PREPARATION OF DEVELOPMENT PLAN FOR MEHERPUR ZILLA

REPORT ON ASSIGNMENT-7

A Report of Checking and validation of different survey output generated by different survey firms (Gangni Upazila).

Image: Incorrect Co-ordinate System

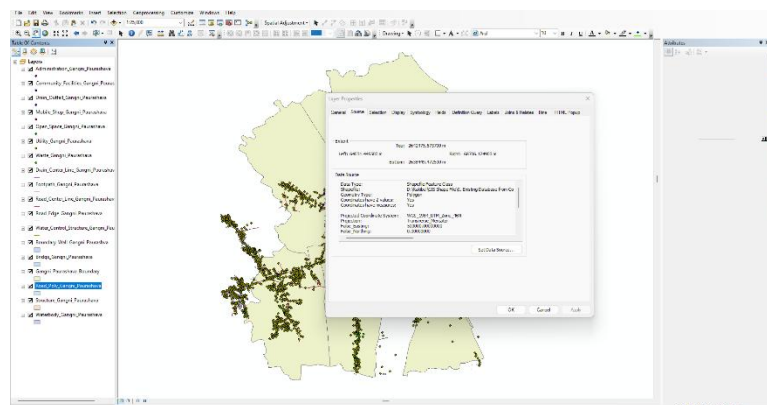
When starting digitization in GIS using geographic coordinates, we first set the projected coordinate system to fix the location, deciding whether the feature will fall in 45N or 46N. Since Meherpur is in the 45N zone, it is necessary to select WGS_1984_UTM_Zone_45N at the beginning of digitization. The consultancy firm initially provided the data projected in the 46N zone, which was incorrect. They later corrected this and provided updated data. However, in one of the datasets, an issue remains when attempting to Zoom to Layer, the entire data appears problematic.

Image: Administrative Location

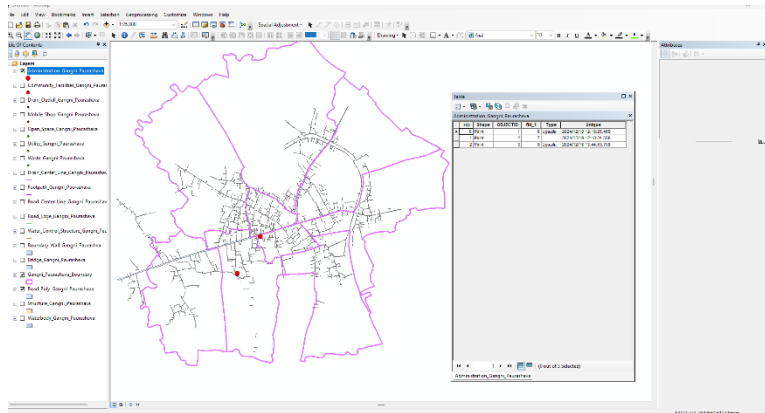
In the case of the administrative data, the firm provided it as a point feature, but there are three data points. Additionally, in the attribute table, there are two entries under the "Type" field with the name "Upazila." However, for this type of data, it can be represented as a structure under "Administrative."

After extracting this data as a separate file and converting it from polygon to point, the issue seems to be resolved.

Image: Community Facilities Location

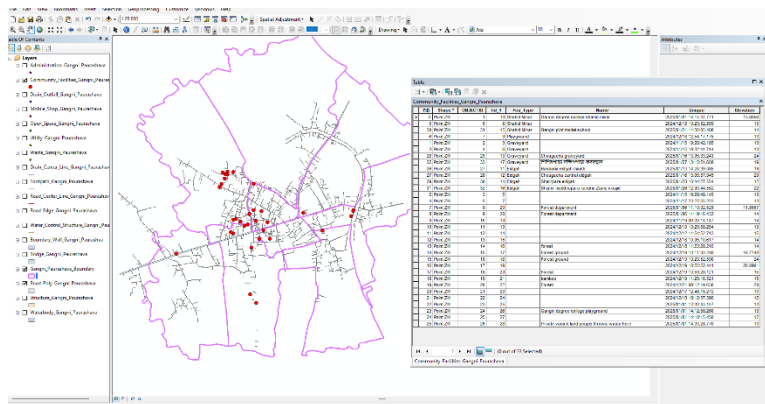
In this data batch, we can see that there are 33 data points. However, most of the fields in the Attribute Table are empty. Specifically, the Fea_Type field is missing information for the majority of the data. In this case, our recommendation is to fill in the missing fields in the Attribute Table to ensure data completeness.

Image: Drain Outfall Location

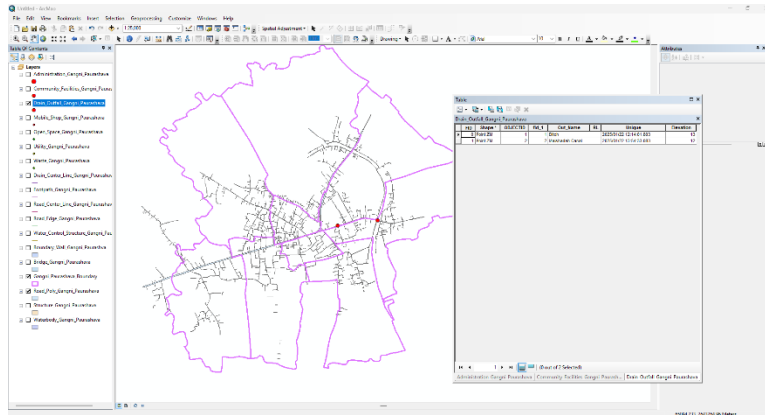
The consultancy firm has created point data for drain outfalls. This point data shows the location, but there are only two data points. Ideally, there should have been more data representing the locations of drain outfalls.

Image: Mobile Shop Location

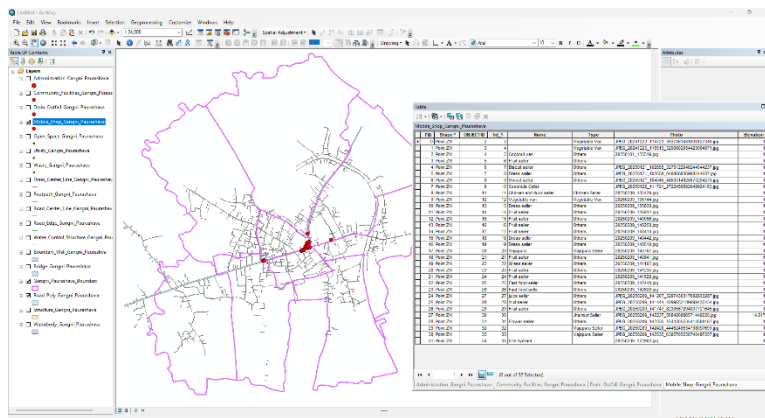
This database contains a total of 32 data points. However, there are some factual errors in the Type and Name fields in the Attribute Table, and some fields are empty, which should have been filled with the correct information.

Image: Open Space Location

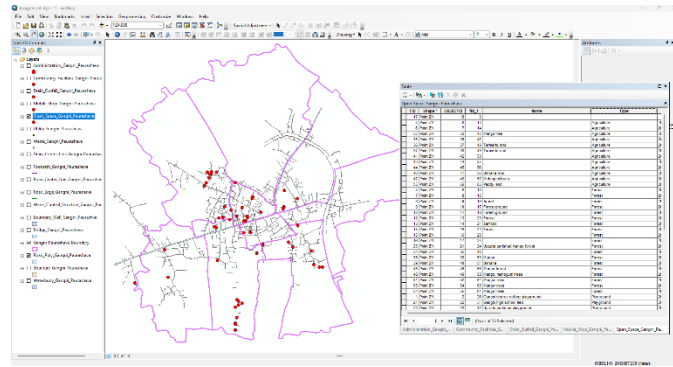
In the “Open Space” shapefile, many fields in the “Type” and “Name” columns of the attribute table are empty. Additionally, the “Name” field contains entries written in both Bengali and English. These issues need some editing.

Image: Utility Facilities Location

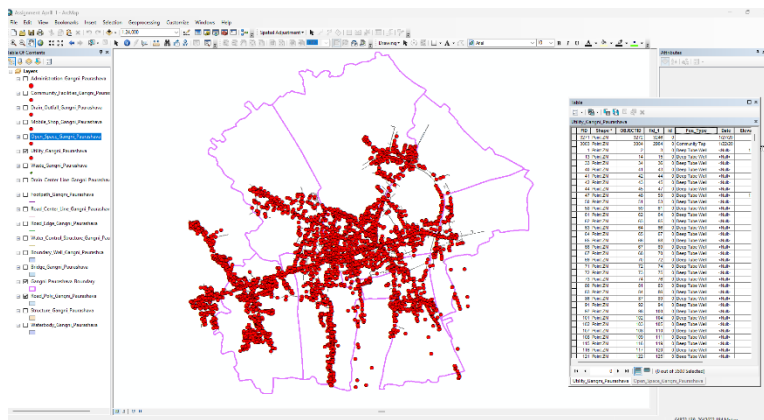
For Utility Facilities, the entire urban area has not been fully covered. This needs some attention. Additionally, areas like Electric Substations and Telephone Exchanges should be represented as polygons.

Image: Waste Dumping Zone Location

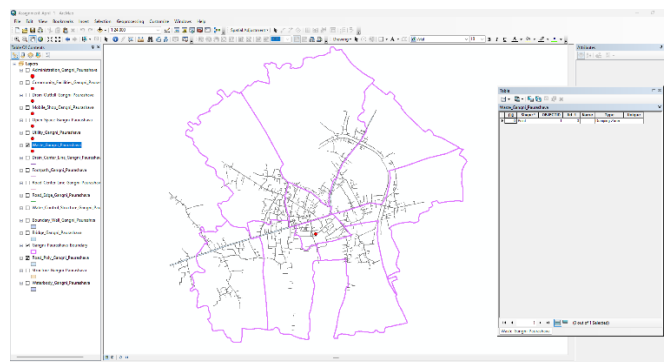
Only one “waste dumping zone” has been shown for the entire area. We believe there might be a few more dumping sites within the entire urban area.

Image: Drain Line Location

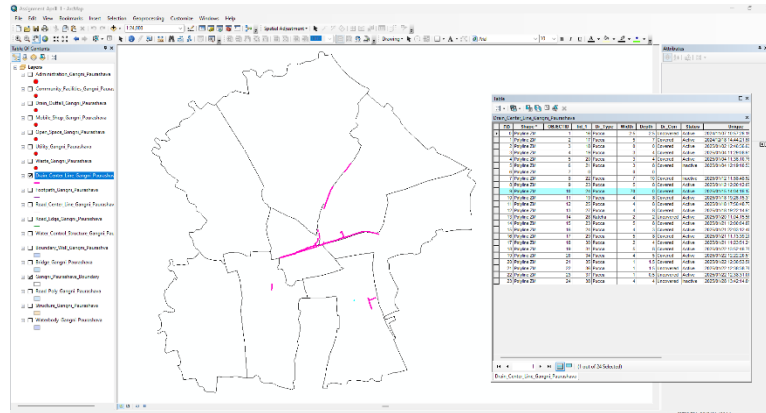
The “Drain Center line” shapefile does not include the drain lines for the “Gangni to Kathuli” and “Gangni to Dhankhola” roads. Additionally, the drain lines along both sides of the “Gangni to Kushtia” and “Gangni to Meherpur” roads are incomplete. Updating these elements in the shapefile will complete the drain line network. Additionally, the width of one drain line is 70 and the depth is 0.

Image: Footpath Location

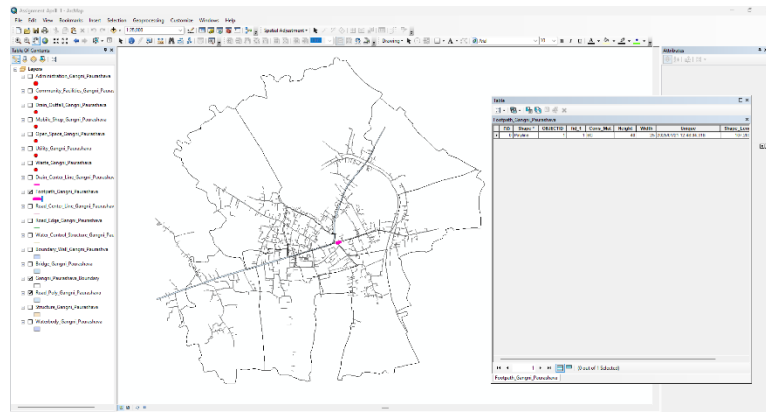
In the “footpath” shapefile, only a small portion of footpaths has been drawn, and that too only along the “Gangni to Alamdanga” road. Footpaths on both sides of the “Gangni to Kushtia” and “Gangni to Meherpur” roads are missing. These footpaths need to be added to this shapefile.

Image: Boundary Wall Location & Drawing Error

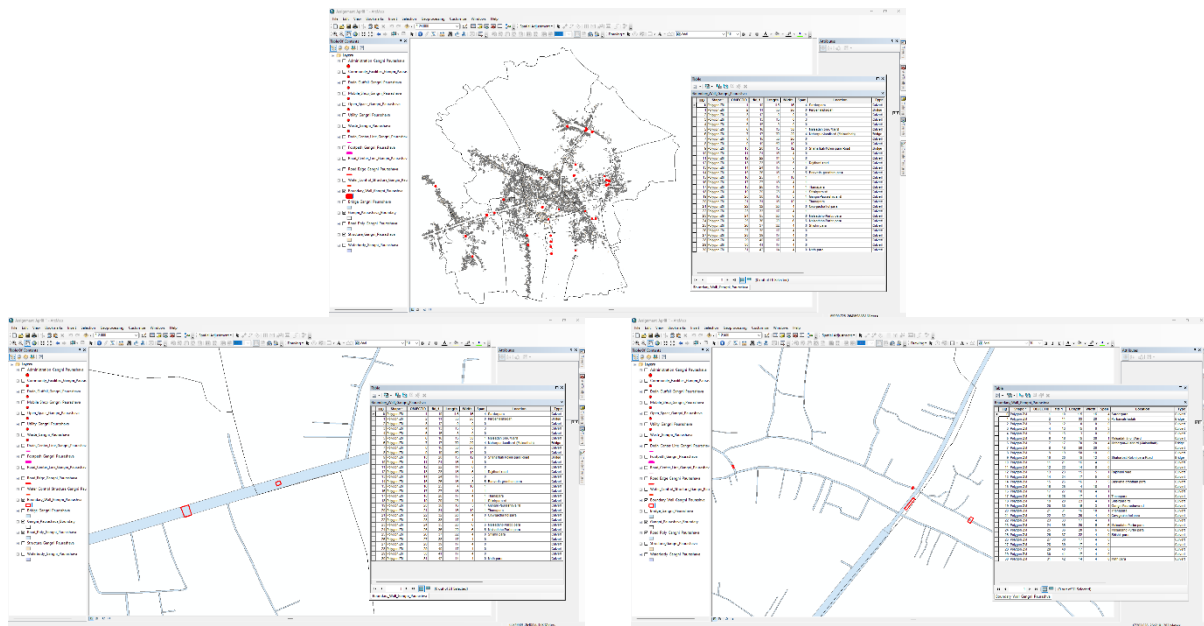
There is a shapefile named “Road Edge” that contains 9 files. It is unclear what “Road Edge” represents, as there is no mention of it in the “ToR”. Therefore, it needs to be assessed whether this “Road Edge” data is actually necessary.

Image: Bridge Location

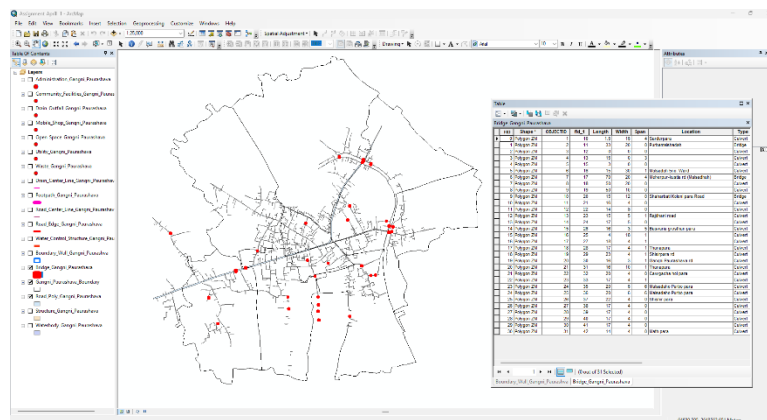
The Bridge shapefile's attribute data contains 31 entries. However, the data in this shapefile is identical to that of the Boundary Wall shapefile. This issue needs to be addressed.

Image: Road Location & Drawing Error

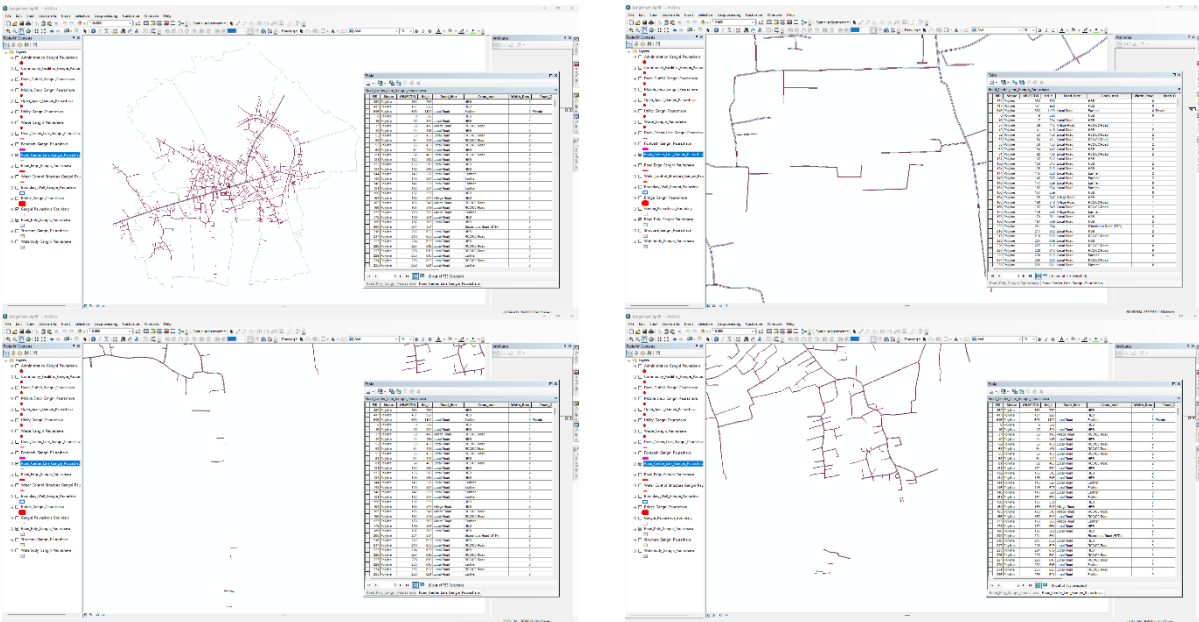
There are two shapefiles for Roads – one is a Center Line file, and the other is a Polygon file. The road data does not fully cover the entire urban area. In many places, roads are present, but the center lines are missing. Conversely, in some cases, center lines exist, but the polygon data is missing. Many fields in the Road Hierarchy are empty. These issues need to be corrected.

Image: Structure Location & Drawing Error

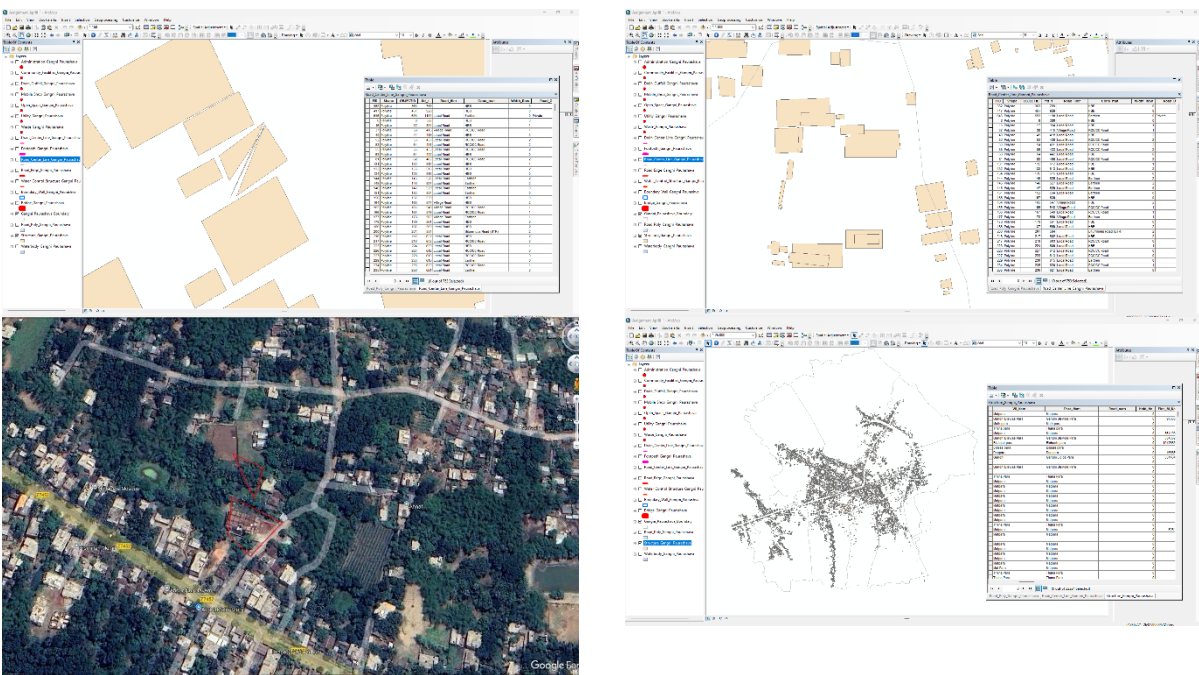
Some data in the Structure shapefile have overlaps, and there are also issues in certain areas. In many places, structures have been drawn where no actual structures exist. Additionally, some structures were not drawn accurately. These issues need to be corrected, and the structure mapping for the entire urban area should be completed.

Image: Water Body Location

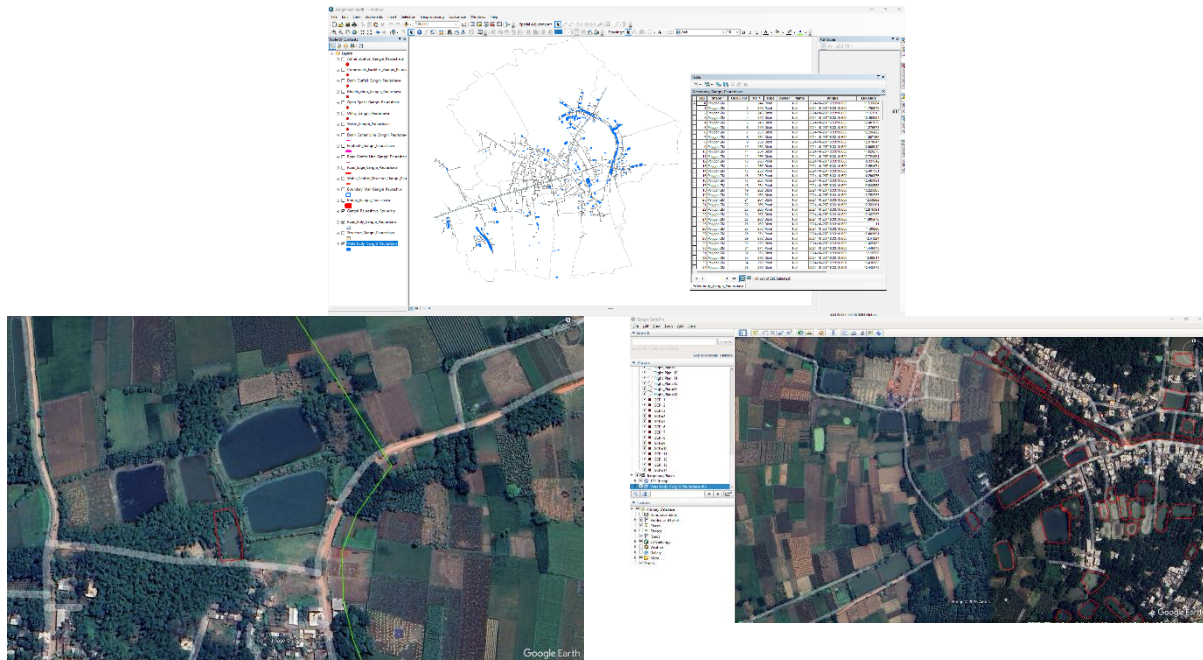
The Water Body shapefile contains a total of 292 data points. However, many other water bodies within the entire urban area have been missed and need to be added.
